Access Compliance Report Public Rights-of-Way (Curb Ramps)

Intersection ID: 14004Main Street: ELMIN_STCross Street: OLD_STEELE_CREEK_RDLocation:SEADA ID: 9391675A6591Ramp Type: ParaDiagInitial Pass/Fail: PassOverall Compliance: NoSeverity Score:0.25

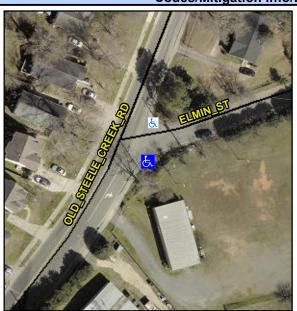
ELMIN ST StopSign OLD STEELE CREEK RD None Possible Solutions:

Remove & Replace Curb Ramp With
Two New Directional Ramps or
Equivalent.

R304.5.3

Compliance Description Data		
N/A	Ramp Length LT (in)	69.0	N/A	Ramp Length RT (in)	55.0	
Yes	Ramp Width LT (in)	60.0	Yes	Ramp Width RT (in)	60.0	
Yes	Ramp Slope LT (%)	5.3	Yes	Ramp Slope RT (%)	5.9	
Yes	Ramp XSlope LT (%)	1.4	No	Ramp XSlope RT (%)	3.3	
Yes	Landing Length (in)	60.0	Yes	DWS Provided?	Yes	
Yes	Landing Width (in)	48.5	Yes	DWS Contrast?	Yes	
Yes	Landing Slope (%)	1.2	Yes	DWS Length (in)	24.5	
Yes	Landing X Slope (%)	0.2	Yes	DWS Full Width?	Yes	
N/A	Landing Curb? (Y/N)	No	Yes	DWS Offset (in)	1.5	
N/A	Shared Landing?	No				
Yes	Gutter Ponding?	No	Yes	Gutter Slope (%)	3.4	
Yes	Gutter Lip Ht (in)	0.0	Yes	Gutter X Slope (%)	0.1	
N/A	Painted X Walk1?	No	N/A	Painted X Walk2?	No	
	X Walk 1 Direction	To N		X Walk 2 Direction	To W	
N/A	X Walk 1 Width (in)	N/A	N/A	X Walk 2 Width (in)	N/A	
	X Walk 1 Slope (%)	1.8		X Walk 2 Slope (%)	0.7	
	X Walk 1 X Slope (%)	0.9		X Walk 2 X Slope (%)	1.4	
N/A	Ramp inside XWalk1?	N/A	N/A	Ramp inside XWalk2?	N/A
